Sunbury South PSP and 35-60 Fox Hollow Drive, Sunbury

STORMWATER MANAGEMENT EVIDENCE STATEMENT

Prepared by Gary Walsh

August 2017

Figure 2. Plan 11 from the Sunbury South PSP showing the location of stormwater management assets and reserves

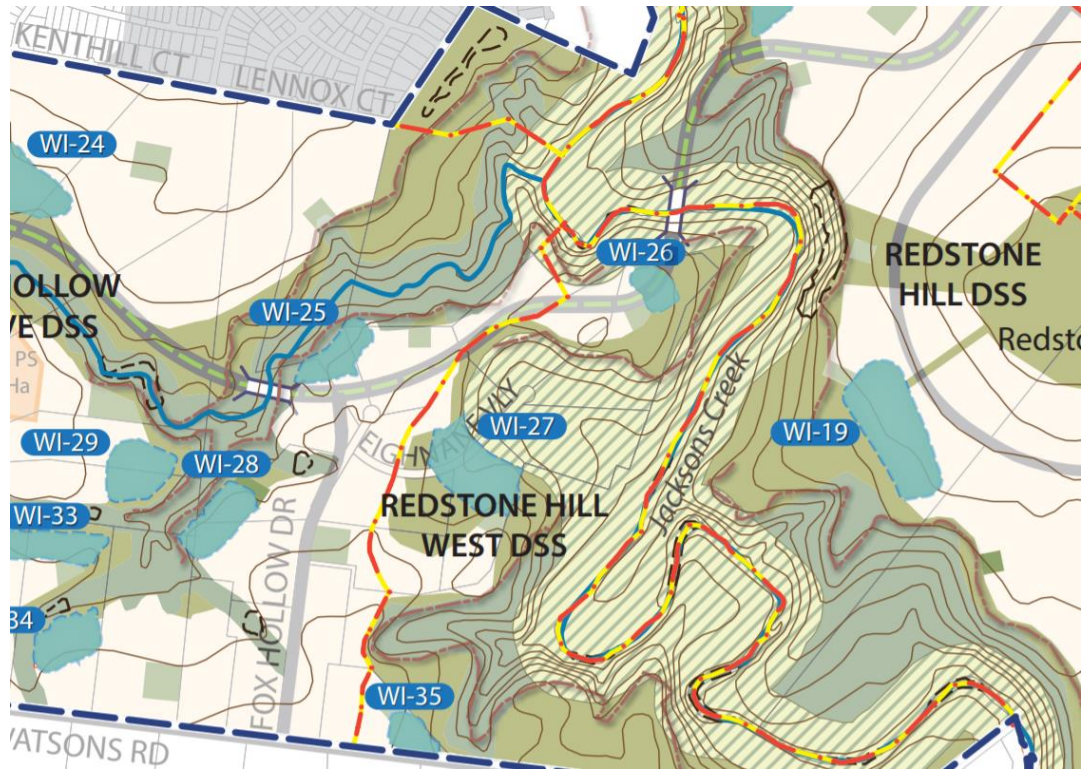
The feasibility of Asset WL-26 is subject to the significant cost of an outfall down the escarpment to the tributary to serve a very small catchment. Ultimately, the development team will verify the economic feasibility of developing its small upstream catchment.

Another issue for this small catchment is that wetlands of this size are inefficient in terms of the required footprint of the reserve (because of buffers, access etc); this creates a lot more reserve for council to manage. My experience of WSUD in Sunbury's climate conditions is that constructed wetlands are generally more resilient than bio-retention systems at a scale typically associated with DSS assets; the primary issues being vegetation health and blockage of the filter media surface. Plant health requires the retention of adequate soil moisture during long dry spells; which is also influenced by adequate spreading of inflows. I have previously been involved in a project commissioned by Melbourne Water to research and advise them on the suitability and recommended adaptations for bio-retention in these climates. My opinion is that in this instance, a bioretention system including a saturated anoxic zone (SAZ) is a viable alternative to a wetland. The relatively small scale of this catchment reduces the challenge of spreading inflows and a SAX provides a reservoir of water beneath the bio-retention filter media which can provide moisture to the plants either directly via deep roots or via

Regardless of my opinion of the viability of bioretention for WL-26, its configuration of Asset WL-26 will need to be negotiated and agreed with Council (as the future asset owner). Beyond preliminary engineering feasibility investigations undertaken by Taylors, the combination of these issues leaves some residual uncertainty in the feasibility of WL-26.

One possible response to improving the feasibility of developing the catchment of WL-26 is to arrange earthworks and drainage so that it predominately drains to WL-25; the balance of its catchment would not be developed. In this scenario, WL-25 would be increased in size marginally.

These issues regarding design solutions for WL-25 and WL-26 may be negotiated and resolved as the development proposals are further progressed, however my opinion is that the need for future flexibility in approving the size and locations of the stormwater management reserves should be acknowledged by the VPA and MW now.

2. I emphasise the need for flexibility in approving the size and location of reserves for WL-25 and WL-26: I support the recommendation in the evidence statement of Andrew Matheson proposing to add a note to Plan 11 in the PSP stating that "confirmation of size and final location of wetland reserves is subject to functional and detailed design approval to the satisfaction of Melbourne Water and Council".

Figure 3. General configuration of Exhibited PSP Scenario for asset WL-27

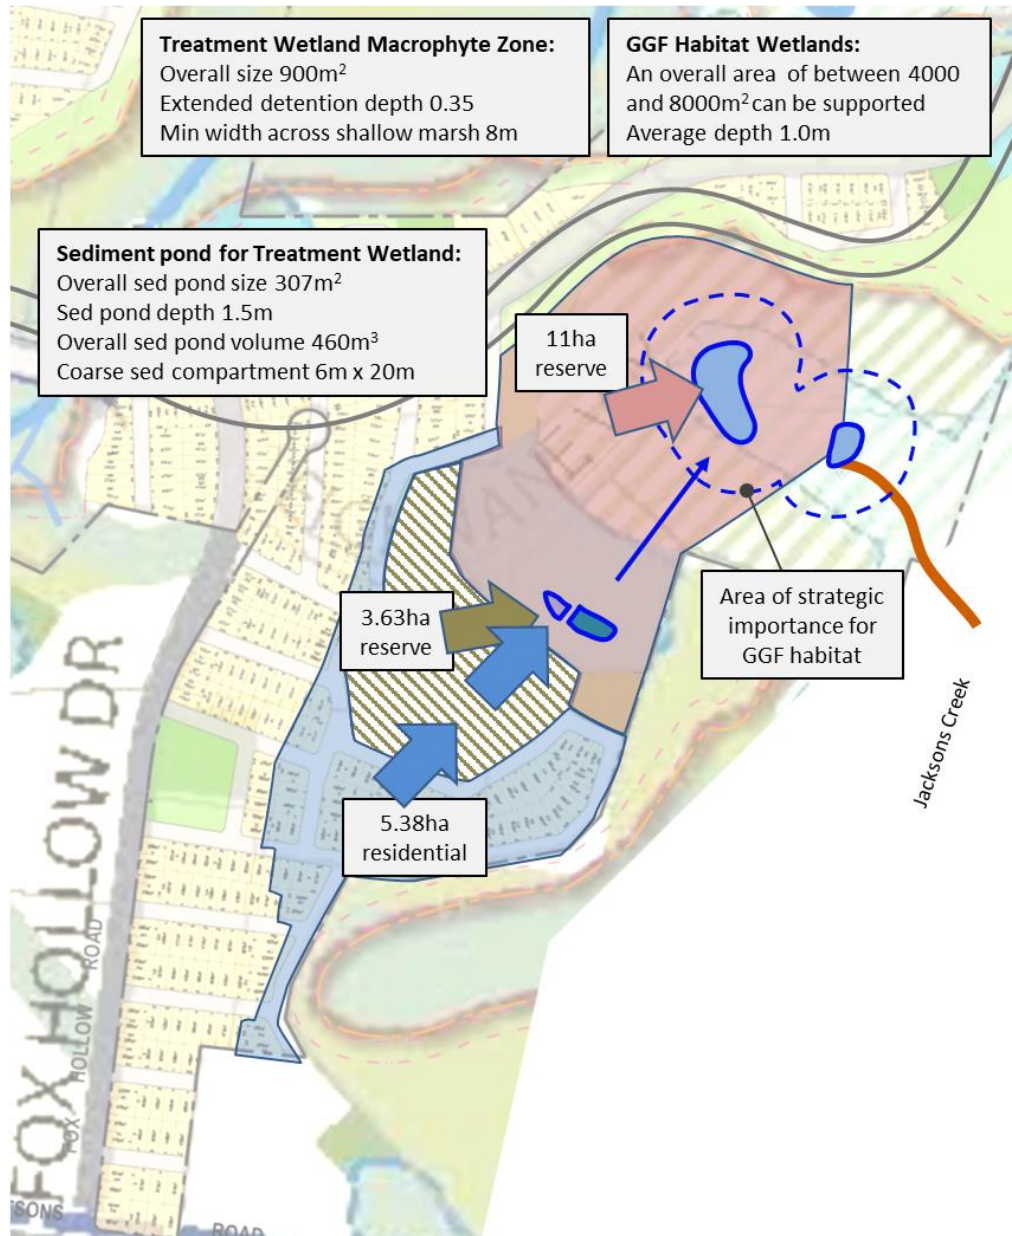
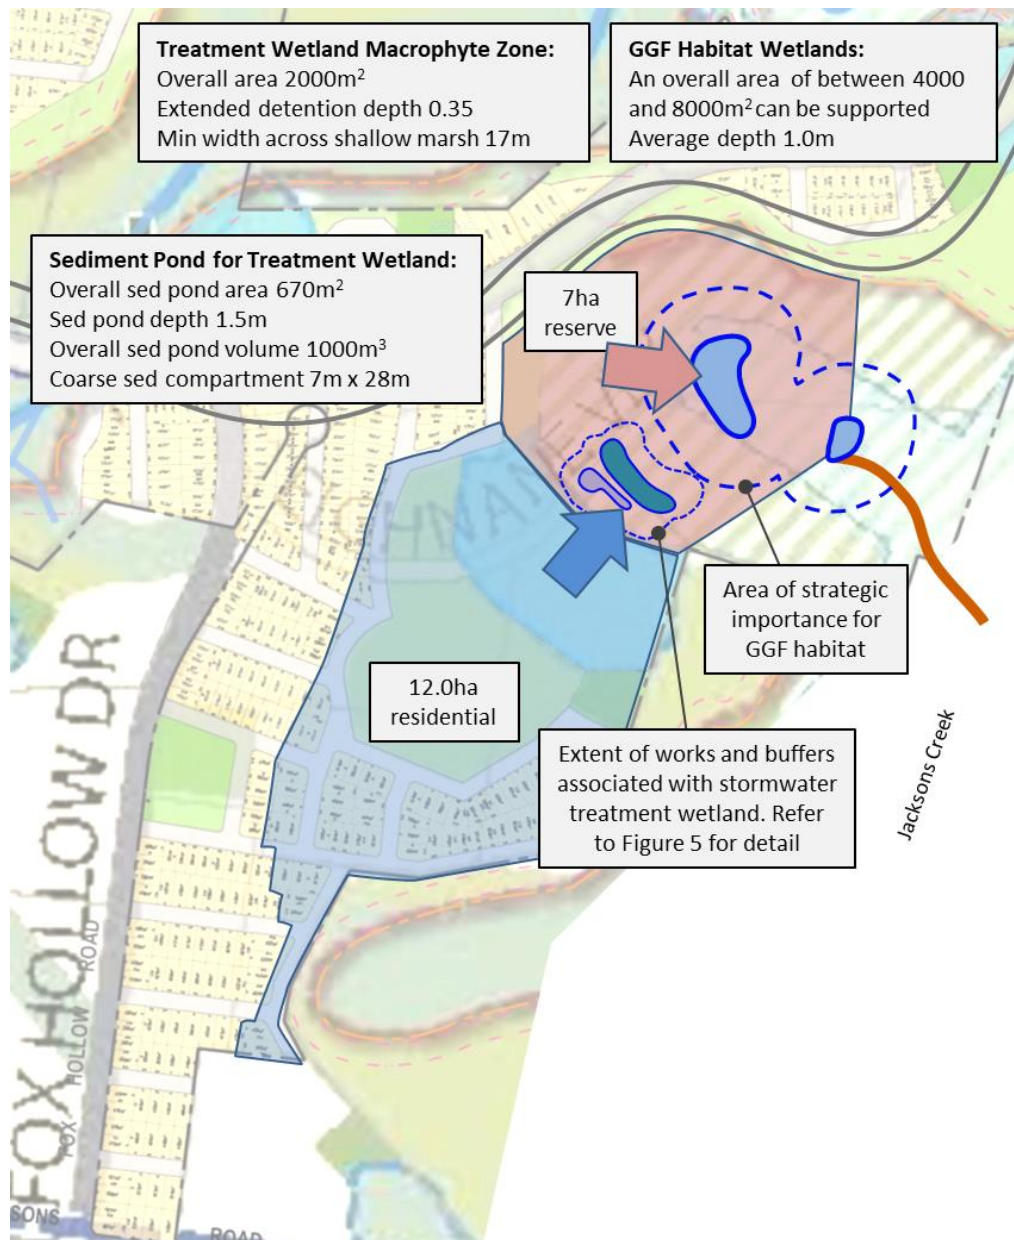
Figure 7 demonstrates that the Co-location scenario has significantly advantage over the 'Exhibited PSP' scenario if exfiltration in the habitat wetland isn't optimal.

My opinion is that although these things can be achieved without the two wetlands being in close proximity, the Co-location scenario would allow maintenance and operational tasks to be marginally more efficient; and may also remind the managers to think of them as a linked system. The following is an example desirable operation phase analysis that are more likely to occur if the wetlands are close to each other: 'are the habitat wetland water levels unusually low? - if so, are the inflow diversion arrangement set correctly? or have the treatment wetlands been taken off-line?.'

My opinion is that the involvement of multiple agencies is a potential barrier to good integrated system analysis and co-location will help to mitigate this risk.

The treatment wetlands and the stormwater connections to Jackson Creek are likely to be constructed before the habitat wetlands. The Co-location scenario will provide all weather access to the conservation area. This will mean the later construction of the habitat wetlands will be less disruptive than otherwise.

- The standard of access required for the treatment wetlands means this capital cost is reduced for construction of the habitat wetlands if the Co-location scenario is adopted.
- Regardless of how management responsibilities are spread across agencies, the smaller overall areas of reserves in the Co-location scenario means less overall operation costs for the community.

1. I support the WL-27 Co-location Scenario: The basis for my conclusion is in three parts:

Figure 6. Comparison of water level behavior in variously sized GGF habitat wetlands subject to various upstream catchment and WSUD configurations

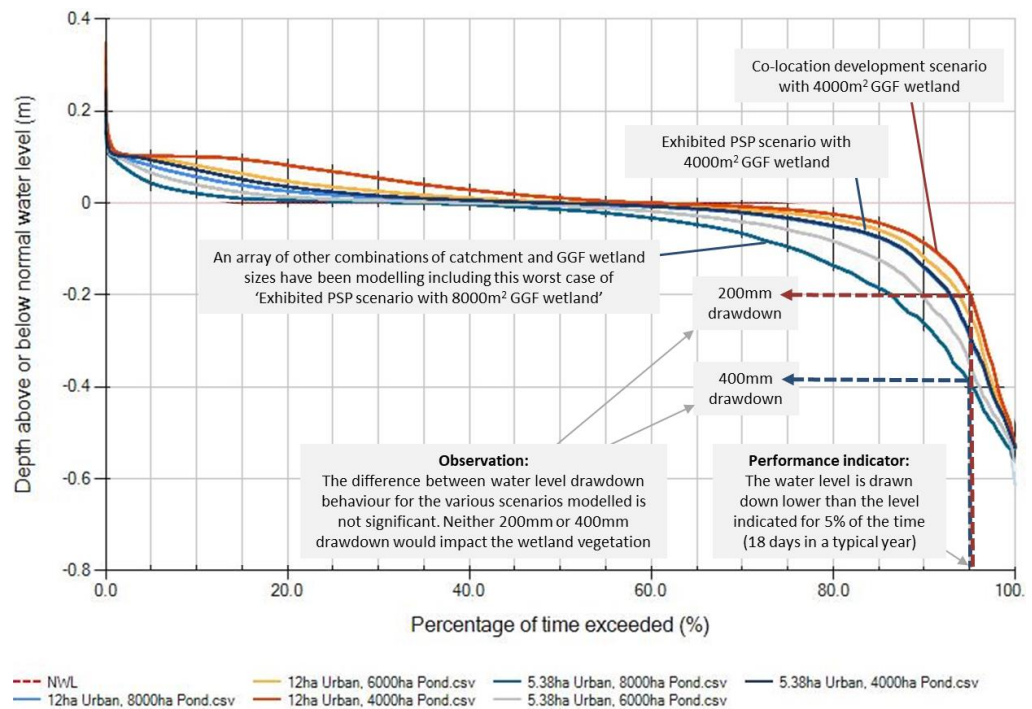
The plots in figure 6 show that the difference between water level drawdown behaviour for the various scenarios modelled were not significant enough to impact aquatic vegetation fringing the wetland. I have been assisted by an aquatic ecologist with industry leading experience in wetland vegetation in this observation. It should be noted that these outcomes are based on a wetland that has no effective exfiltration losses; this assumes a well compacted heavy clay base protected by topsoil.

*my observation is that a well-constructed 4000m² wetland would be **adequately supported by either the 'Exhibited PSP' or 'Co-located' scenarios and that an increase of wetland area up to 8000m² would also be adequately supported by either scenario.***

Figure 7. Comparison of water level behavior between 'Exhibited PSP' and 'Co-location' scenarios for a 4000m² habitat wetland with 0.36mm/hr exfiltration.

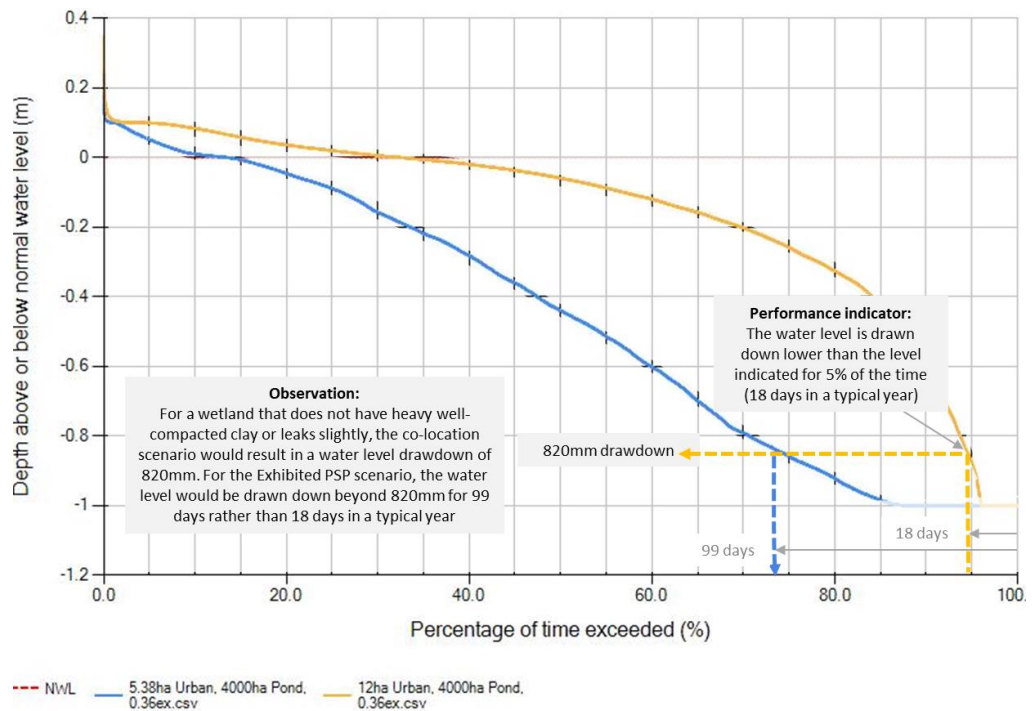
The sensitivity of a 4000m² habitat wetland was then tested against changes in exfiltration rates. The analysis showed that acceptable water level behaviour was quite sensitive to this factor and that the maximum tolerable exfiltration rate was 0.36mm/hr under certain conditions. It should be noted that medium clays, poorly compacted clays or a moderate leak would not comply with the 0.36mm/hr maximum rate.
